# HISTORIC AND DESIGN REVIEW COMMISSION

**HDRC CASE NO:** 2017-467  
**ADDRESS:** 423 N HACKBERRY ST  
**LEGAL DESCRIPTION:** NCB 576 BLK 15A LOT N 30.32 FT OF 12  
**ZONING:** RM-4 H  
**CITY COUNCIL DIST.:** 2  
**DISTRICT:** Dignowity Hill Historic District  
**APPLICANT:** John Brearley  
**OWNER:** John and Irene Brearley  
**TYPE OF WORK:** New construction of a 2-story single family home  
**REQUEST:**

The applicant is requesting conceptual approval to construct a new two-story single family home on the vacant lot at 423 N Hackberry St.

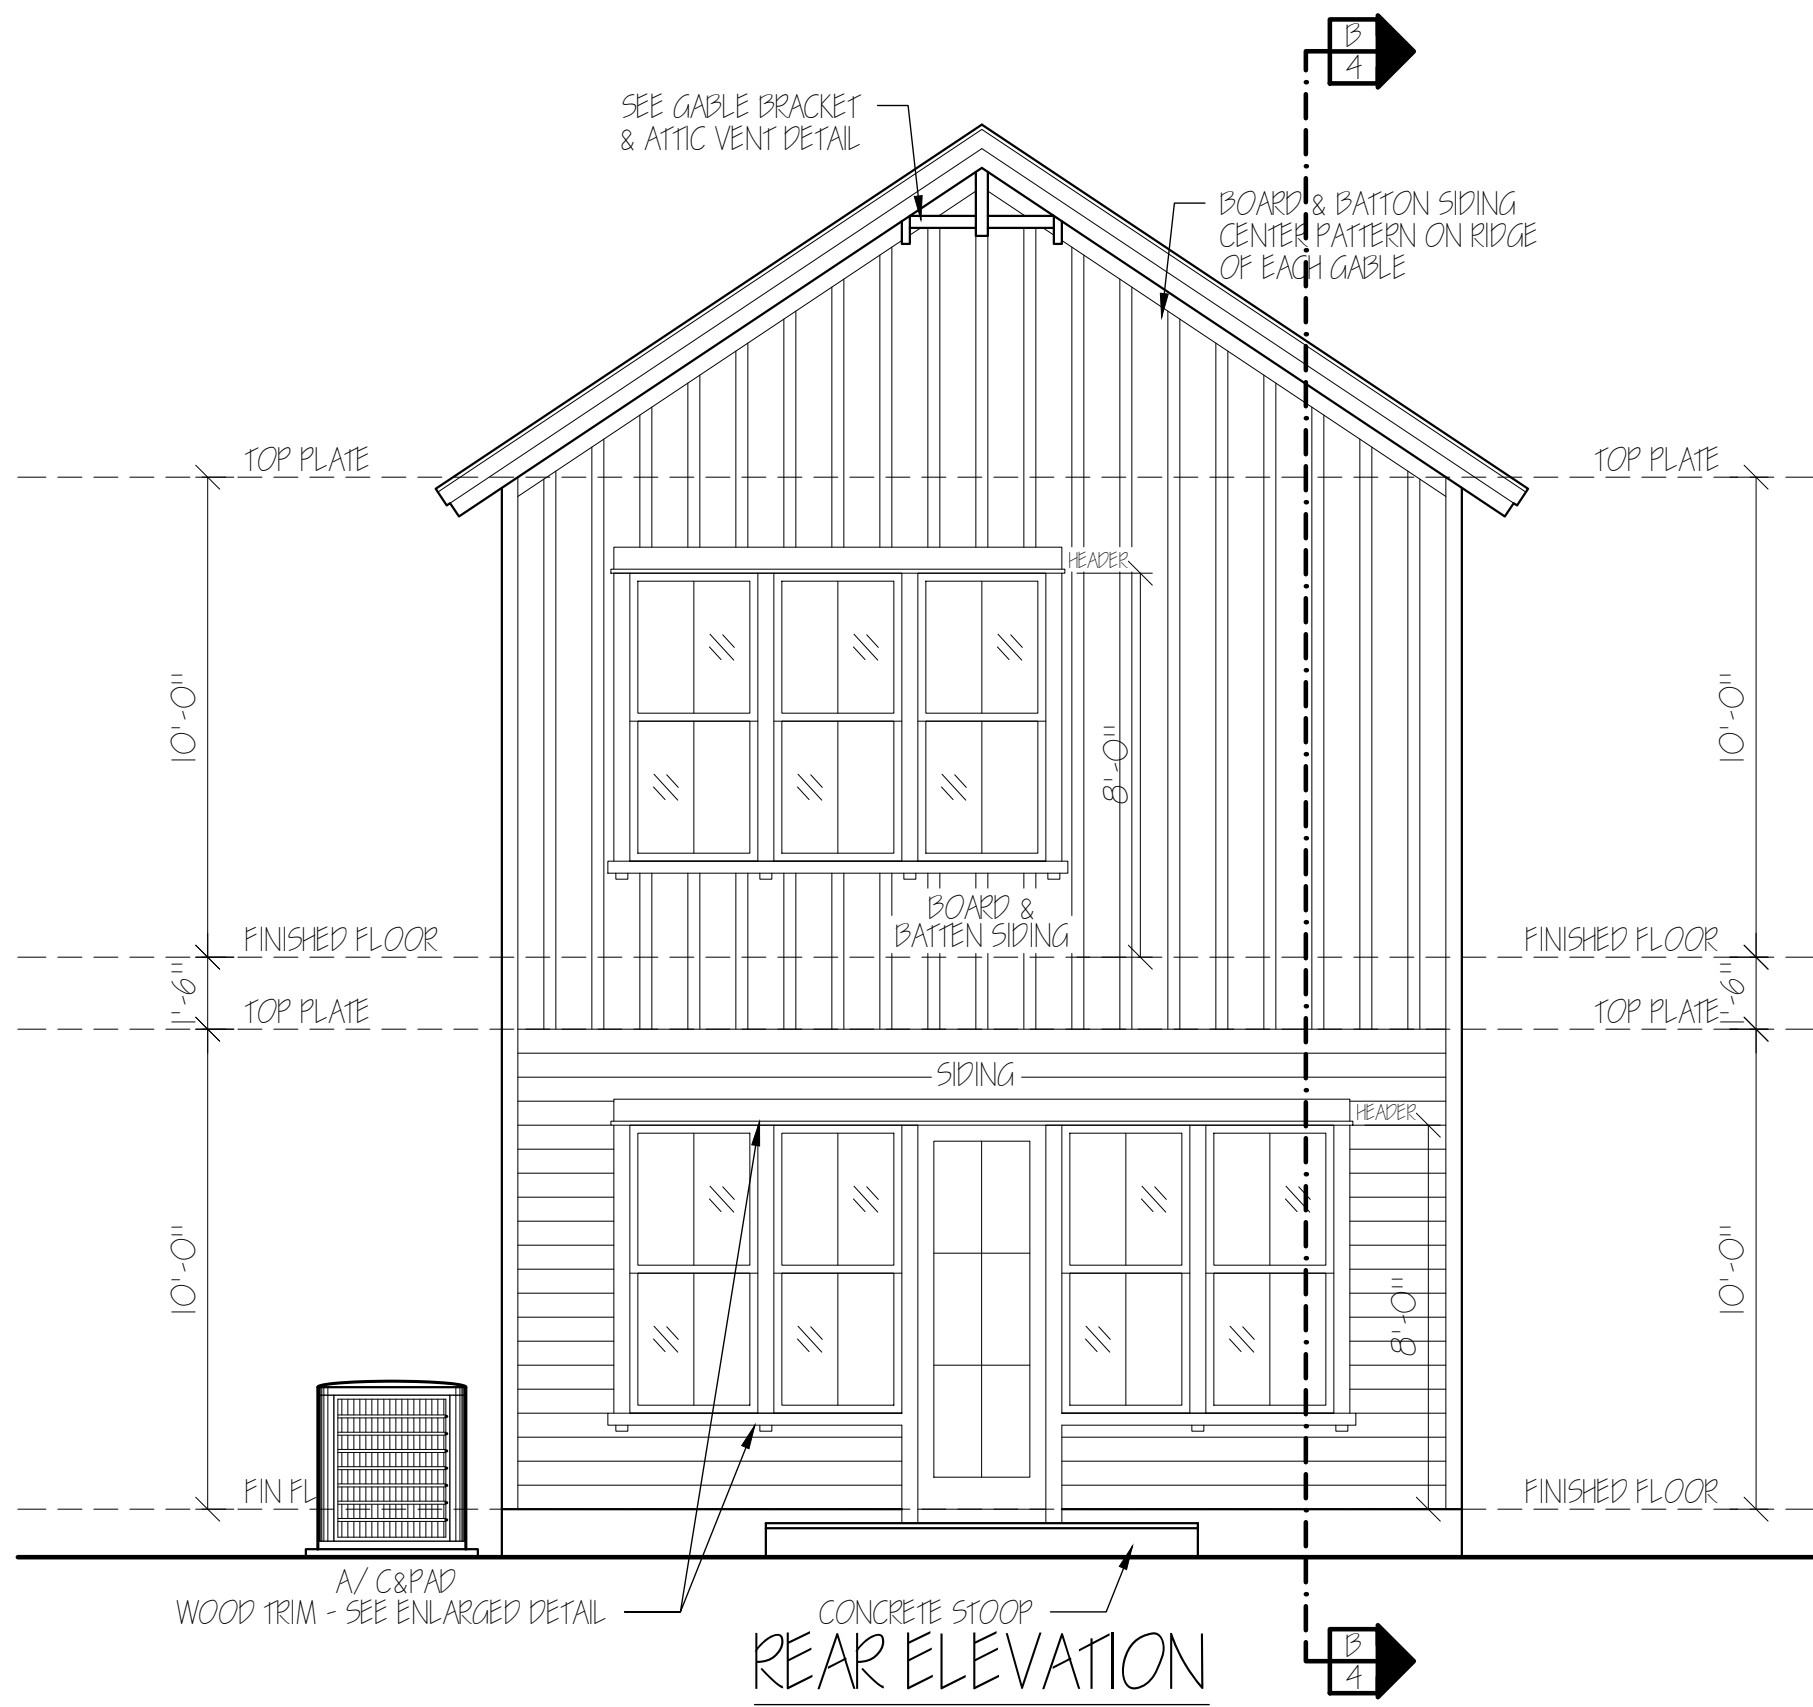
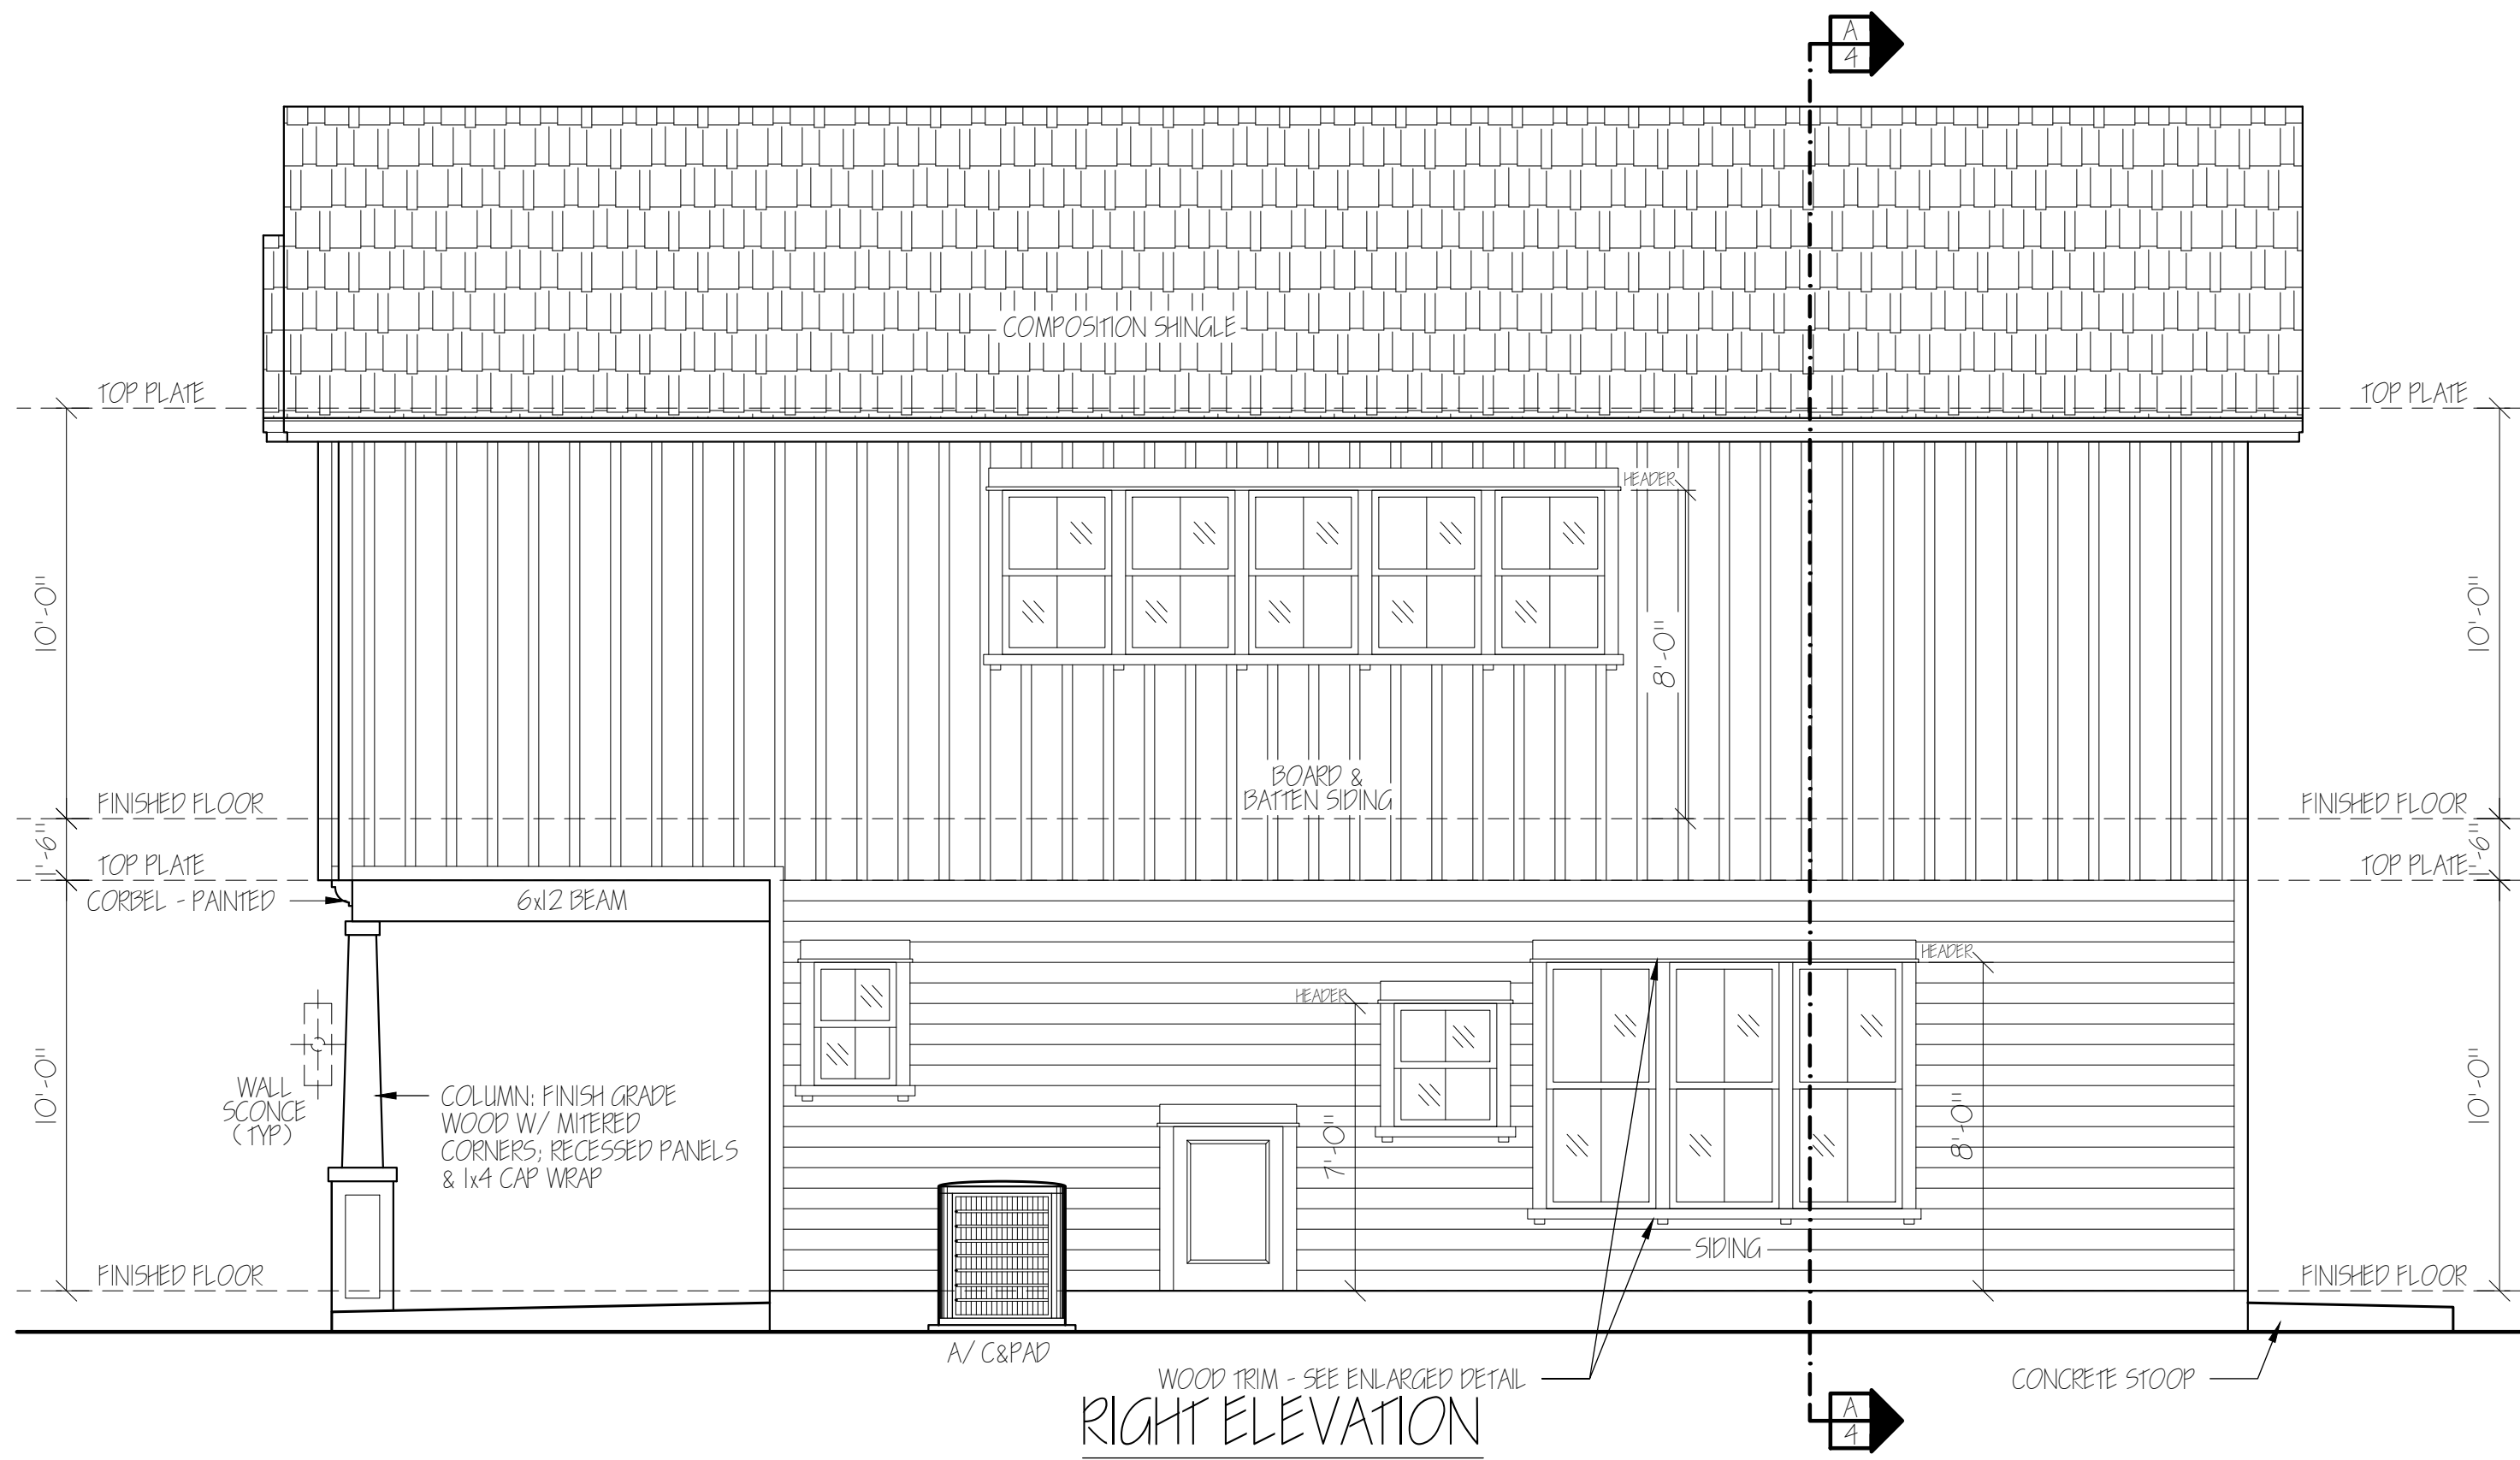
- f. **SCALE & MASS** – Per the Guidelines for New Construction 2.A.i., a height and massing similar to historic structures in the vicinity of the proposed new construction should be used. In residential districts, the height and scale of new construction should not greatly exceed the historic precedent. The only remaining historic residential structure on N Hackberry between E Houston and Glorietta is 2 stories. The remaining historic structures in the vicinity on Glorietta are 1-story. The applicant has noted on the submitted drawings that the proposed ridge line will be 28'-10" from the finish floor, which is approximately one foot from grade, bringing the total height to approximately 29'-10" feet. Both the first and second stories will feature 10'-0" tall interior ceiling heights separated by a web truss measuring 1'-6". The neighboring 2-story historic structure features a first floor ceiling height of 10'-0" and a second floor ceiling height of 8'-0". Staff does not find the proposed height to be consistent with the Guidelines. Staff finds that the overall height should be reduced through the shortening of the second story or the lowering of the top plate height to produce an overall height that is comparable with the heights of neighboring, historic structures.

- g. **PORCH CONFIGURATION AND MASSING** – The applicant has proposed to incorporate a front porch on the front façade of the new structure. The porch mass will be inset approximately 6" from the front façade. The Historic Design Guidelines state that porches on new construction should be reflective of the development pattern of the district. Typically in historic districts, including Dignowity Hill, residential porch massing elements project the furthest towards the streetscape to engage pedestrians. Two story structures feature a second story that is set back from the porch. As proposed, the structure's second story extends over the front porch, which increases the massing on the street. This is addressed in Guideline 2.A.ii, which states that step-downs in building height, wall-plane offsets, and other variations in building massing to provide a visual transition should be utilized. There is no historic precedent in the district for this porch form or massing strategy. Staff finds the porch inconsistent with the Guidelines.

- h. **FOUNDATION & FLOOR HEIGHTS** – According to the Guidelines for New Construction 2.A.iii., foundation and floor height should be aligned within one (1) foot of neighboring structure's foundation and floor heights. The applicant has noted that the foundation will be slab-on-grade and have a minimal height. Historic structures on this block feature foundation heights of approximately eighteen (18) to twenty-four (24) inches. This is generally inconsistent with the Guidelines and the surrounding context.

- j. **WINDOW & DOOR OPENINGS** – Per the Guidelines for New Construction 2.C.i., window and door openings with similar proportions of wall to window space as typical with nearby historic facades should be incorporated into new construction. The applicant has proposed window and door openings that are generally consistent with those found on historic structures in regards to location and size with the exception of the right and left elevations, which feature several small fixed windows that are not consistent with the OHP Window Policy Document or historic fenestration precedents in the district, as well as a series of ganged windows with minimal trim separation between them. All proposed window detailing can be modified to relate closer to historic examples, such as the use of approximately six inches of separation between double windows. Each window should be inset at least two (2) inches within walls to ensure that a proper façade depth is maintained.

1. That the applicant provides information noting the setbacks of adjacent historic structures on a contextual site plan.
2. That the applicant reduces the proposed height through the shortening of the second story or the lowering of the top plate height to produce an overall height that is comparable with the heights of neighboring historic structures.

3. That the applicant sets the second story back from the front façade and modifies the front porch configuration and massing as noted in finding g. The porch should be the mass that projects furthest towards the streetscape to reflect the developmental context of the area.

4. That the applicant explores ways to incorporate a raised foundation for a front porch or pedestrian entry to be more consistent with neighboring historic structures as noted in finding h, if feasible.

5. That the applicant explores ways to construct a driveway along the side of the proposed new construction as noted in finding p.
6. That the applicant introduces window sizes and proportions that are more consistent with the Historic Design Guidelines, the OHP Window Policy Document, and adjacent historic structures to the right and left elevations as noted in finding i.
